TO: Mercedes-Benz Dealer Principals, General Managers, Sales Managers, Service Managers, Parts Managers	FROM: Thomas Brunner, Department Manager, Vehicle Compliance and Analysis, Engineering Services
RE: <b>Service Campaign 2016040003</b> <b>Model 190, AMG GT-S Model Year 2016</b> <b>Check Both Rear Axle Upper Control Arms,</b> <b>Replace if Necessary</b>	DATE: August 5, 2016

Campaign No. 2016040003, August 2016

SUBJECT: **Model 190, Model Year 2016**  
**Check Both Rear Axle Upper Control Arms, Replace if Necessary**

Figure 1

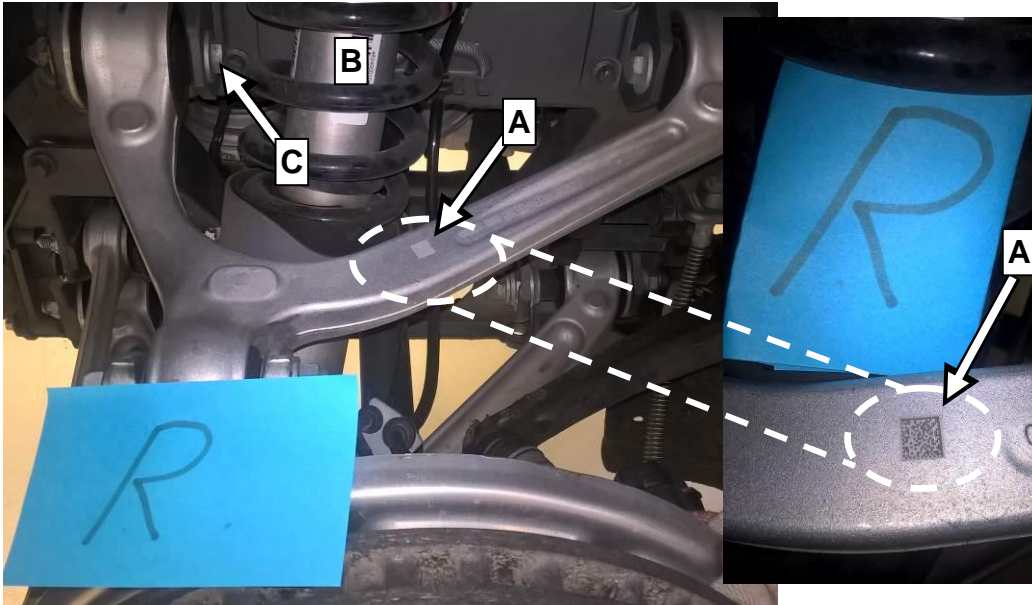
1.  Remove rear wheels.
2. Take a picture of the QR code sticker (A, Figure 1) on the upper rear axle control arms:
  - Clearly mark control arm installation location (R for right, L for left) in the pictures as shown.
  - Clean QR code with rag without solvent.
  - Refer to Figure 1 for example of photograph of right rear upper control arm.

3. Create PTSS case:
  - Submit pictures along with VIN.
  -  **Note:**
    - Pictures submitted must be of good quality and high resolution.
    - No SDS print out is required.
    - Wait until guidance is provided by Engineering Services.
  - If Engineering Services indicates control arm(s) do not require replacement (**OK**): Reassemble in reverse order.
  -  If Engineering Services indicates control arm(s) require replacement (**NOT OK**), proceed to next step.
4.  Replace upper control arm, refer to  WIS: AR35.20-P-0121RQ.
